For Official Use Only 請勿填寫此欄	Application No. 申請編號	AK1/236
	Date Received 收到日期	21 OCT 2019

Re: Proposal Relaxation of Plot Ratio for Non-Polluting Industrial Development at Nos. 20-24 Tai Yau Street, San Po Kong, Kowloon
Section 16 Planning Application for Approved Tsz Wan Shan, Diamond Hill and San Po Kong Outline Zoning Plan No. S/K11/29

Response to Comments

FIGURE 2.2

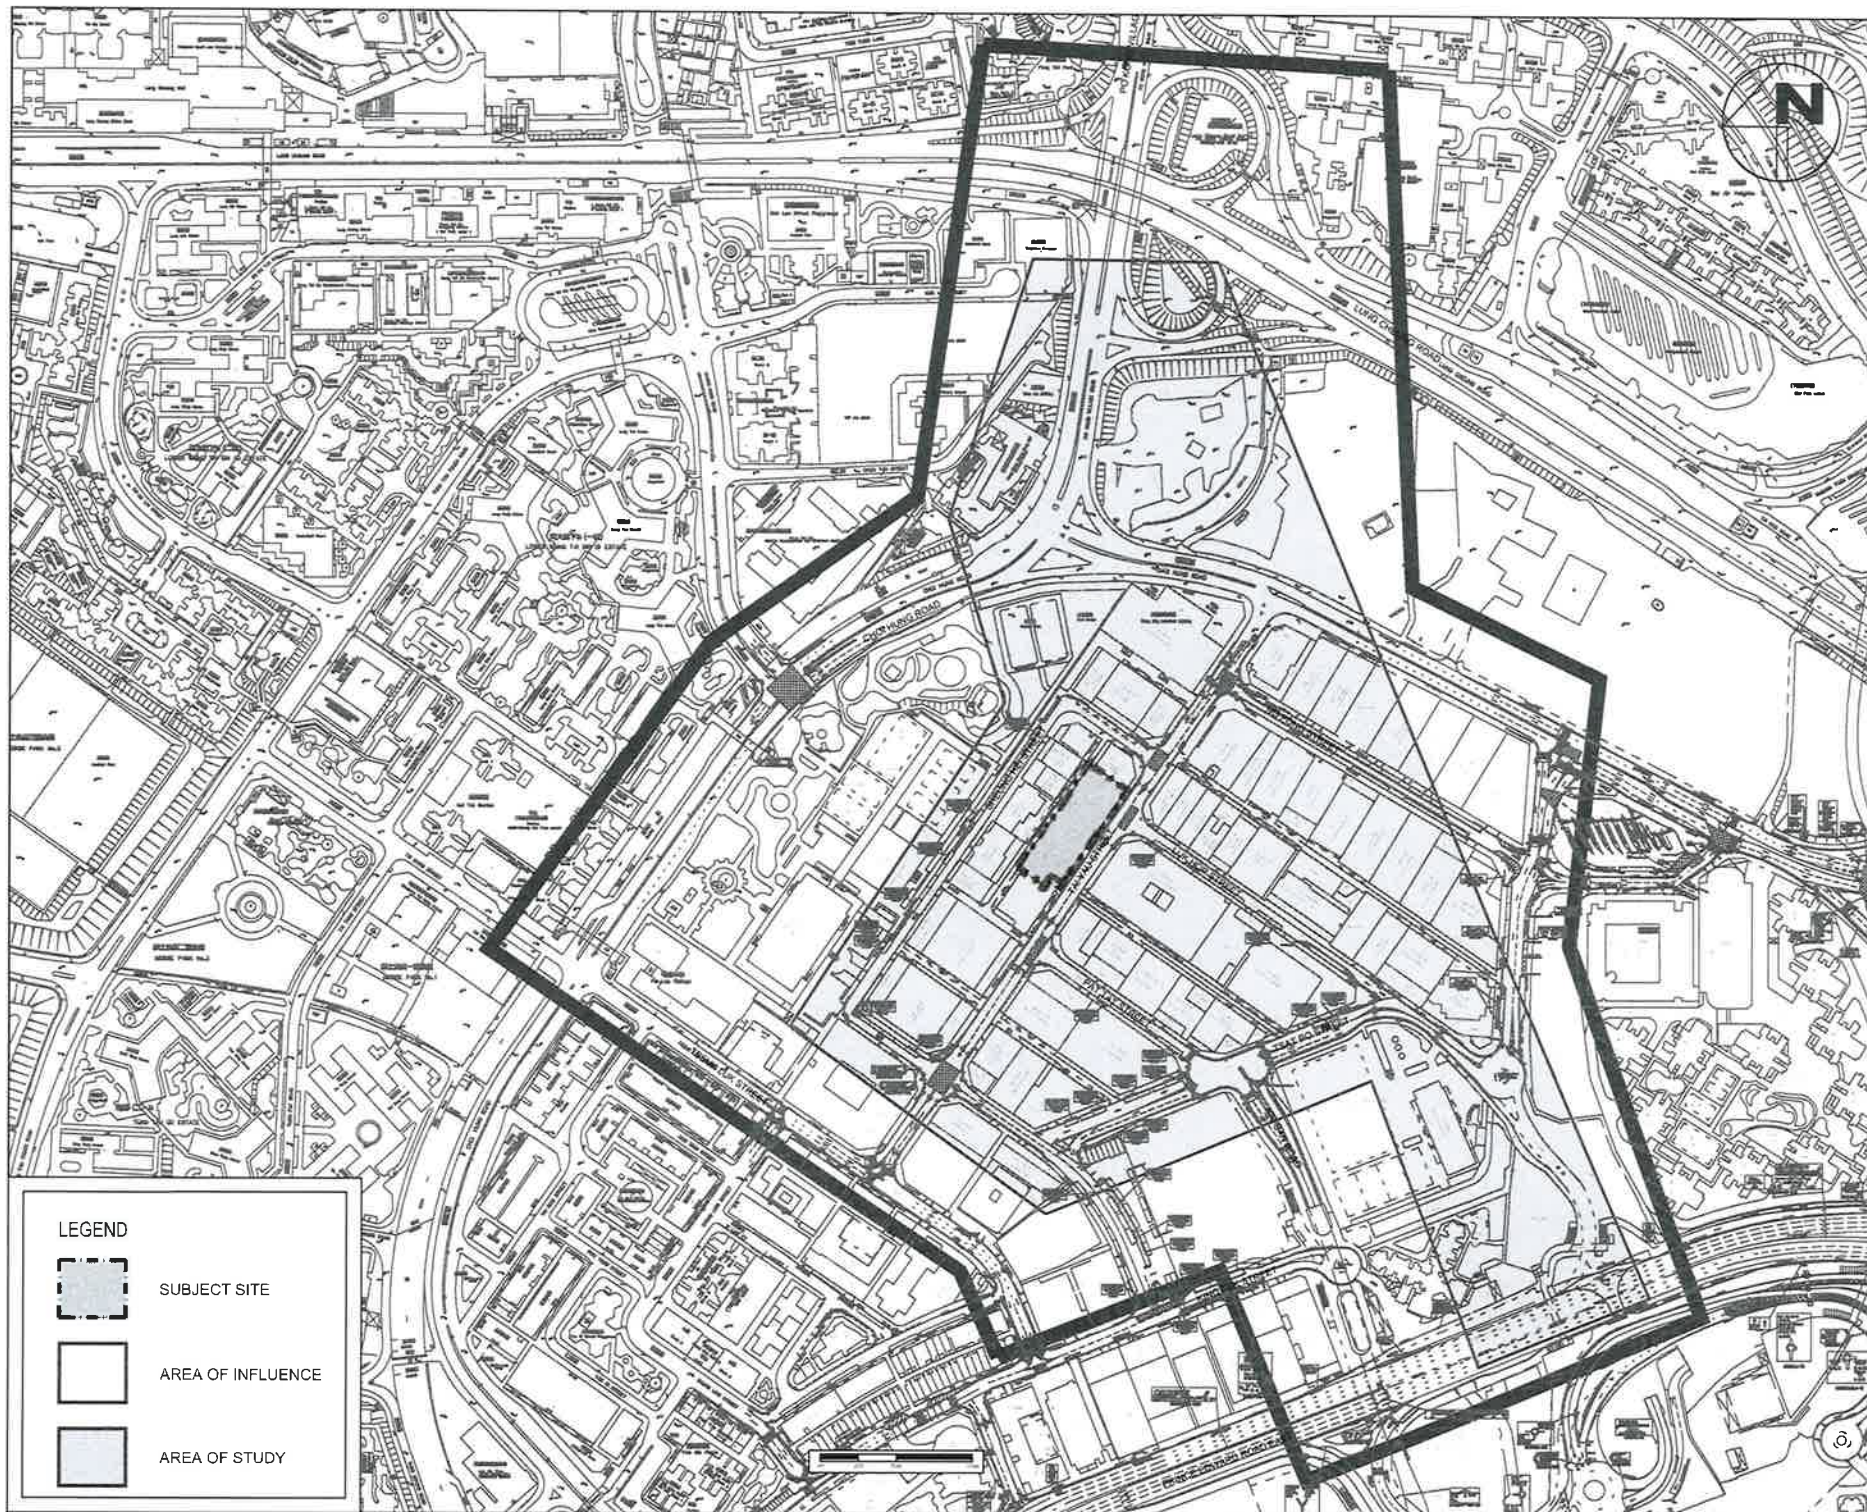
<p>(vi) Please find the following comments on the Traffic Impact Assessment (TIA) Report in Appendix IV of the Supporting Planning Statement:</p> <p>a) Area of influence is missing;</p> <p>b) Other planned and committed development in the vicinity including but not limited to public vehicle park at Sze Mei Street, Holistic Centre for Youth Development at Tsat Po Street shall be taken into consideration in the assessment. Please also include a plan showing the planned and committed development;</p> <p>c) Please advise the details of “existing scheme” referred in Section 4.2;</p> <p>d) Please clarify the planning data and TPEDM data as shown in Section 4.4;</p>	<p>Noted. The area of influence is enclosed herewith as Figure 2.2 for your review and comment.</p> <p>Traffic Assessment Report is under reviewing and revised Report will be submitted to the estimated traffic generation.</p> <p>Noted. According to the lease, the existing GFA of 20 Tai Yau Street and 22-28 Tai Yau Street are 44,645.86 ft² (i.e. 4,147.74 m²) and 187,407.56 ft² (i.e. 17,410.73 m²) respectively. The proposed site at 20-24 Tai Yau Street will take up the area of the land of 20 Tai Yau Street and one-third of 22-28 Tai Yau Street with a total area of 9,951.31 m². In accordance with TPDM, the generation and attraction in the morning(evening) are 9(14) and 14(10) respectively.</p> <p>Noted. Planning data “Projections of Population Distribution 2019-2028” is used in the report.</p>
